Paper for Consideration by ENCWG5 Proposed Revision of S-58

Submitted by:	ENCWG S-58SubWG
Executive Summary:	This paper proposes a number of new S-58 checks and the existing S-58 checks.
Related Documents:	S-58 edition 6.1.0, ENCWG4-5.8, ENCWG4-5.11, ENCWG4-5.13A, ENCWG4-5.13B, ENCWG4-5.17, ENCWG4-5.22, ENCWG4-5.25
Related Projects:	-

Our chart extract:

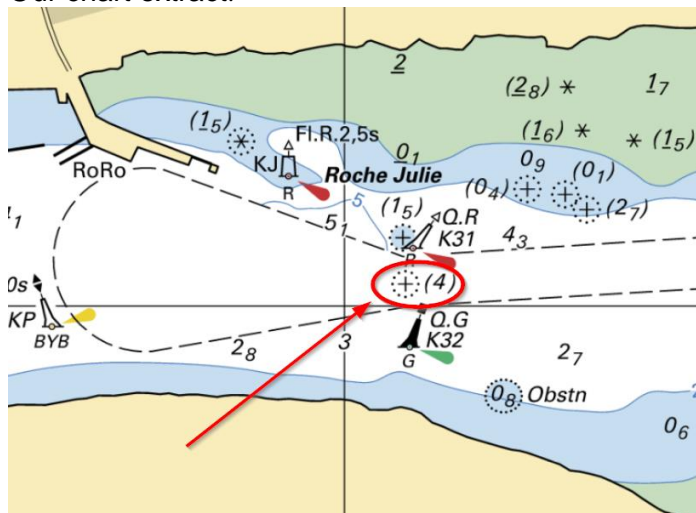
Proposal from SHOM

I have a proposal to improve S58 check 61b which triggers an Error when an UWTRC (and surely other objects) with WATLEV=3 are encoded on a DRGARE.

61b	For each feature object of geometric primitive point where WATLEV is Equal to 3 (always underwater/submerged) which is not COVERED_BY a DEPARE feature object where DRVAL2 is Greater than 0 AND is not COVERED_BY a DRGARE feature object OR is COVERED_BY a LNDARE feature object of geometric primitive point or line.	Point object where WATLEV = 3 (always underwater/submerged) is not covered by a suitable depth area.	Amend value of WATLEV.	Logical consistency	E
-----	---	--	------------------------	---------------------	---
